The amendment revises the Technical Specifications to (1) incorporate new maximum average planar linear heat generation rate (MAPLHGR) curves for two new barrier fuel types to be used in the upcoming operating Cycle 8 and approve extended MAPLHGR curves for assembly average burnup of 45,000 MWD/ST for certain fuel types that will comprise part of the core for the upcoming operating Cycle 8; (2) change the calibration and functional test frequencies for certain specific instrumentation that is being modified into analog trip systems; and (3) incorporate appropriate Technical Specifications for operation with the newly modified scram discharge system.

QUAD CITIES NUCLEAR POWER STATION, UNIT 2  
AMENDMENT TO FACILITY OPERATING LICENSE

Amendment No. 86  
License No. DPR-30

SAFETY EVALUATION BY THE OFFICE OF NUCLEAR REACTOR REGULATION  
SUPPORTING AMENDMENT NO. 86 TO FACILITY OPERATING LICENSE NO. DPR-30

Figure 3.5-1 (Sheet 4 of 6) Maximum Average Planar Linear Heat Generation Rate (MAPLHGR) vs. Planar Average Exposure

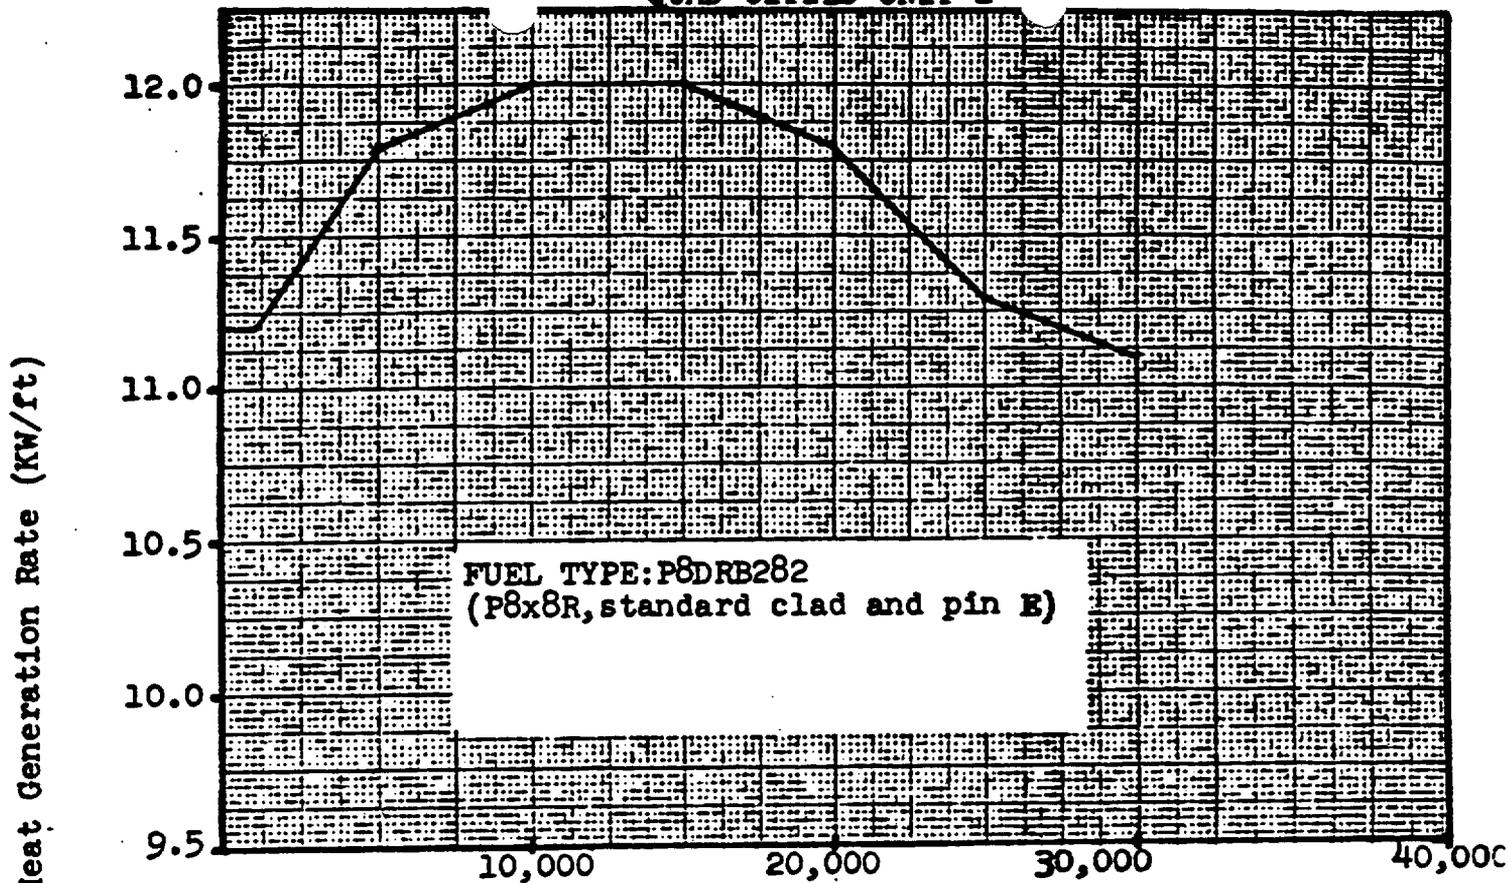
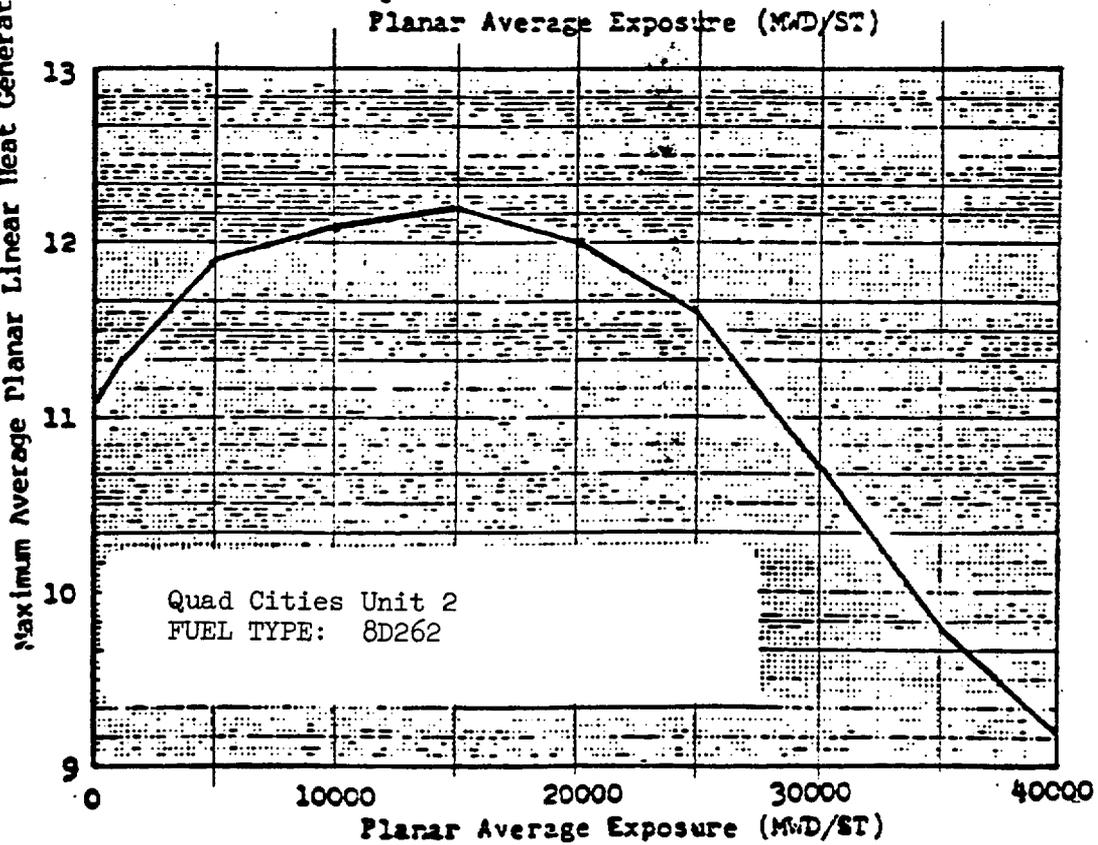
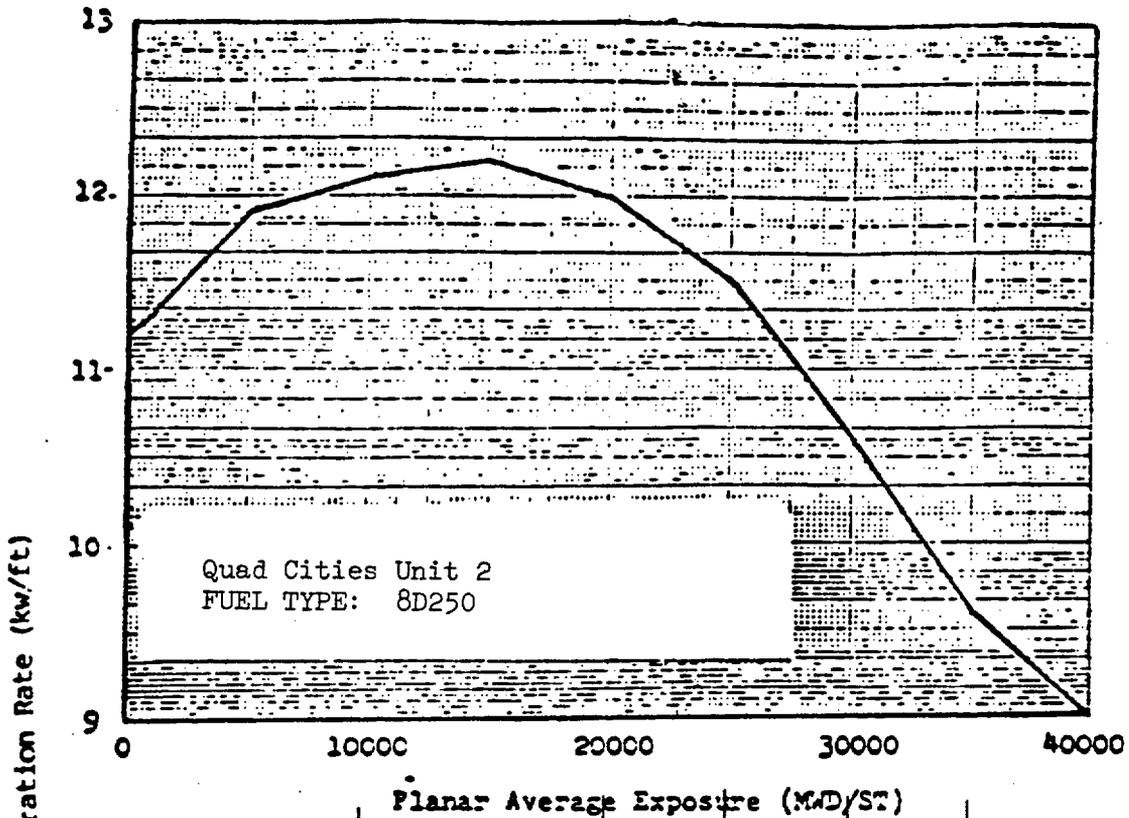
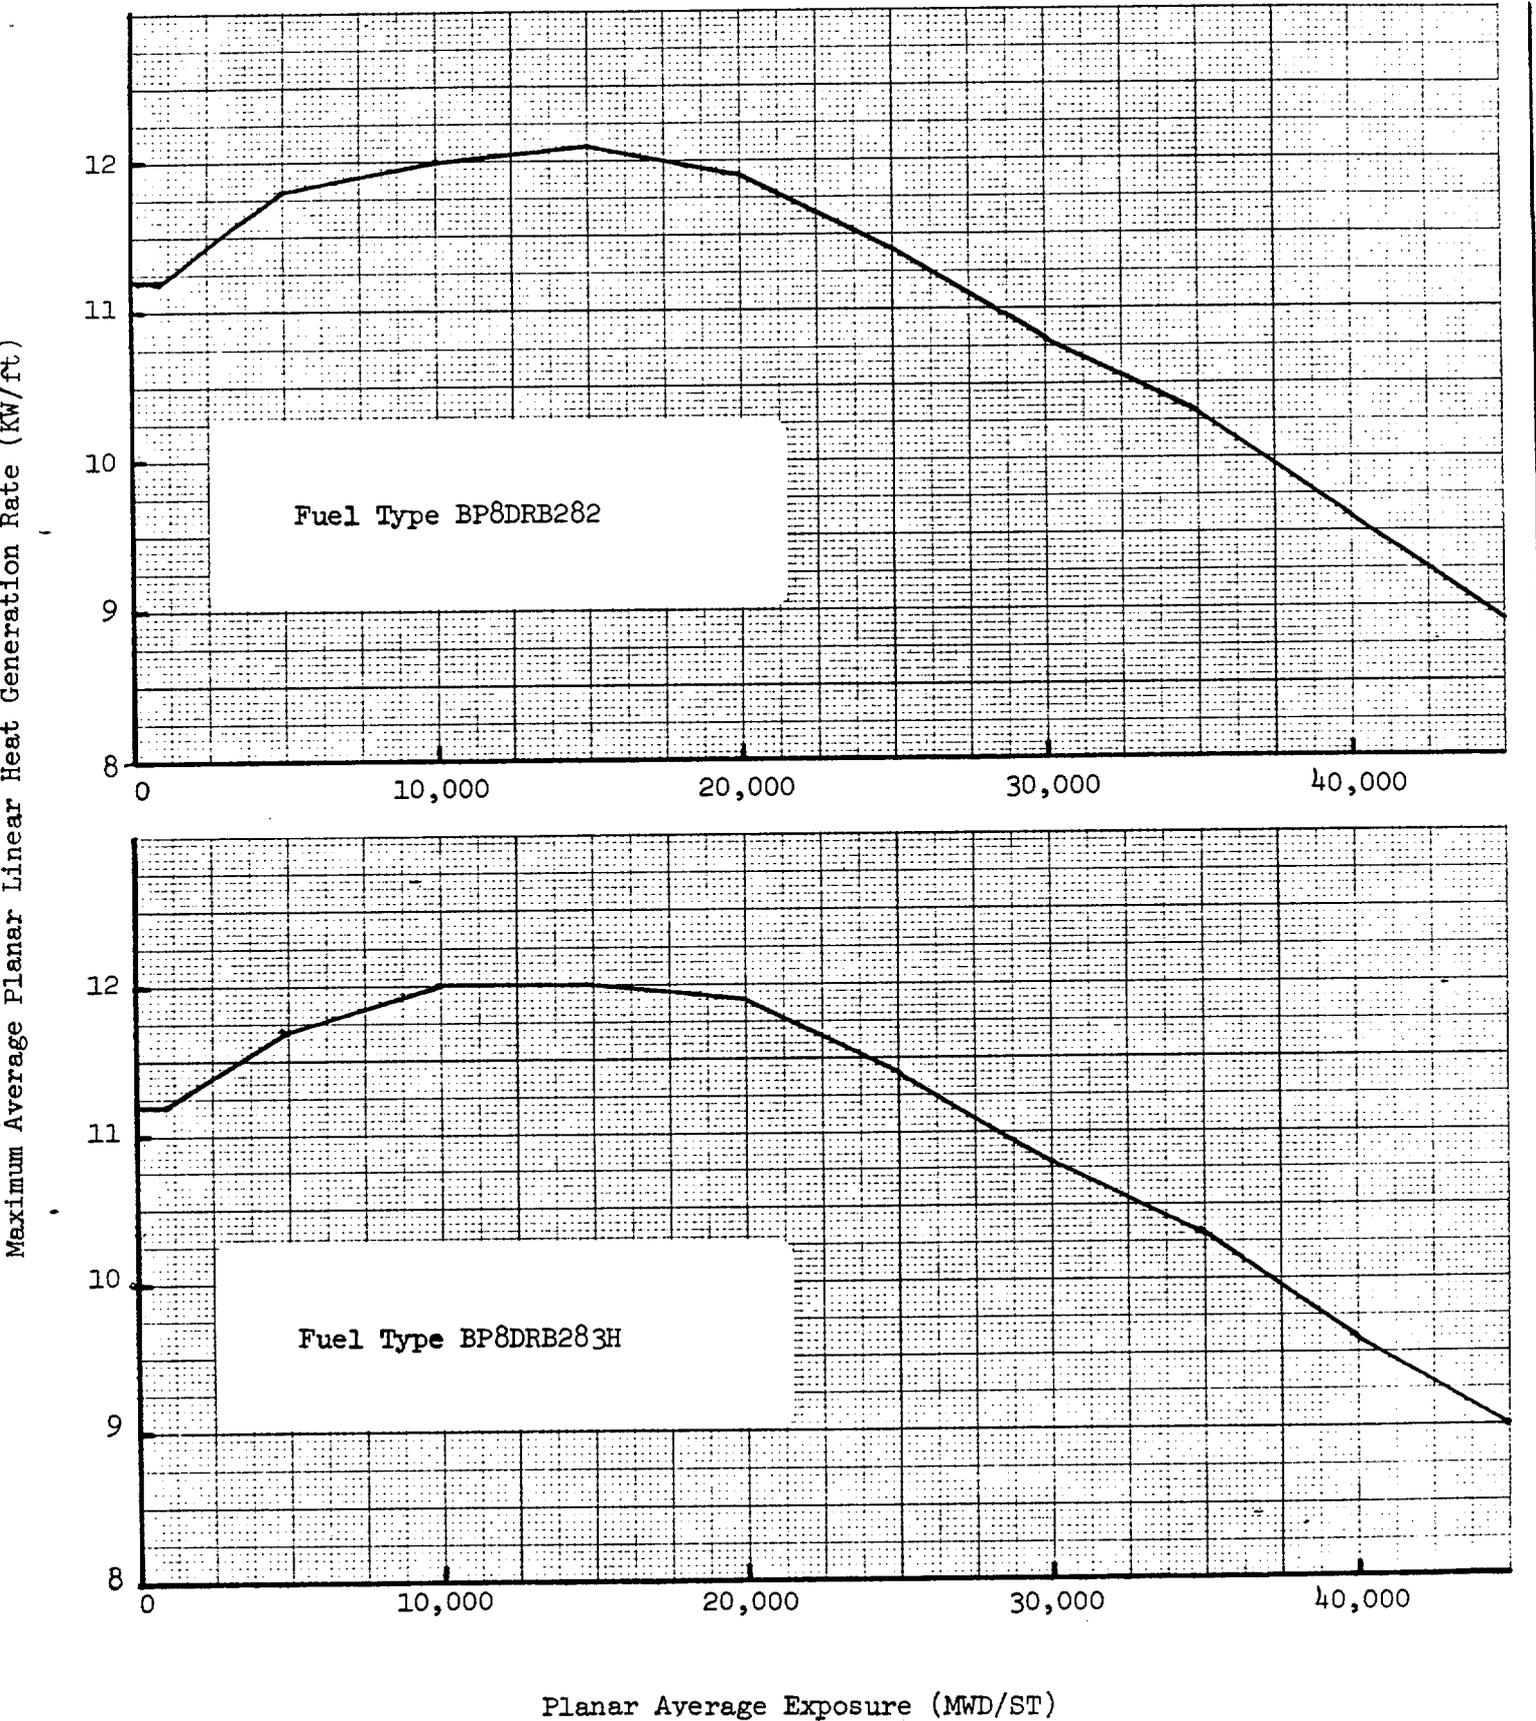
By letters dated January 3 and February 4, 1985, Commonwealth Edison Company (CECo, the licensee) proposed changes to the Technical Specifications (TS) for Quad Cities Unit 2 (see References 1 and 2). These changes would (1) incorporate new maximum average planar linear heat generation rate (MAPLHGR) curves for two new barrier fuel types to be used in the upcoming operating Cycle 8, and approve MAPLHGR curves for assembly average burnup to 45,000 MWD/ST for certain fuel types contained in the core during upcoming operating Cycle 8; (2) change the calibration and functional test frequencies for certain specific instrumentation that is being replaced with analog trip systems; and (3) incorporate appropriate TS for operation with the newly modified scram discharge system.

The reference document containing the emergency core cooling system (ECCS) analysis for Quad Cities Unit 1 and 2 (as well as Dresden Units 2 and 3) has previously been approved by the NRC staff and continues to be the basis for MAPLHGR limits for all fuel types used in these units (Reference 4). This reference document has been updated as appropriate for other fuel types by issuance of Errata and Addenda (E and A) to Reference 4. Barrier fuel types BP8DRB282 and BP8DRB283H, to be used in the core during the upcoming operating Cycle 8 for Quad Cities Unit 2, have previously been approved for use in Quad Cities Unit 1 (Reference 3) and are currently being used in operating Cycle 8 of that nuclear unit. The licensee's application (Reference 2) provides E and A No. 13 to the previously approved ECCS analysis for Quad Cities Unit 1 and 2 (Reference 4). As did E and A No. 12 for Quad Cities Unit 1, so does E and A No. 13 to Reference 4 show that the MAPLHGR curves for fuel types BP8DRB282 and BP8DRB283H satisfy the requirements of the 10 CFR 50.46 acceptance criteria, and are appropriate for incorporation into the TS for Quad Cities Unit 2, so that the licensee's proposal to change the TS to incorporate those MAPLHGR curves into the TS is acceptable.

The licensee's application (Reference 2) also contains a request to approve an extension of MAPLHGR limits to assembly average burnup of 45,000 MWD/ST for two fuel types already in the core. By E and A No. 10 to Reference 4, provided in the licensee's application (Reference 2), the licensee supports an extension to MAPLHGR curves from 30,000 to 45,000 MWD/ST for fuel types P8DRB265H and BP8DRB265H. These limits were generated by method previously approved and having general applicability for MAPLHGR limit determination (Reference 5). In response to NRC staff concerns that the possible effects of enhanced fission gas release were not adequately considered in the fuel performance model, GE requested that credit for approved but unapplied ECCS evaluation model changes and calculated peak cladding temperature margin be used to avoid MAPLHGR penalties at high burnups (References 6 and 7). This proposal was found acceptable (Reference 8) provided that certain plant-specific conditions were met. As documented in the licensee's application (Reference 2), the General Electric Company (GE)-produced supporting reference document demonstrates the applicability to Quad Cities Unit 2 operating Cycle 8. Further, the staff has investigated potential changes in the radiological consequences of the fuel handling accident (the design basis accident) due to the possible involvement of extended burnup (as high as 45,000 Mwd/MT) fuel in the accident scenario, and concludes that new radiological consequences would not be in excess of the Standard Review Plan (SRP) guideline value of 75 REM to the thyroid. On the basis of the foregoing considerations, the extended MAPLHGR limits for the fuel types cited are acceptable.
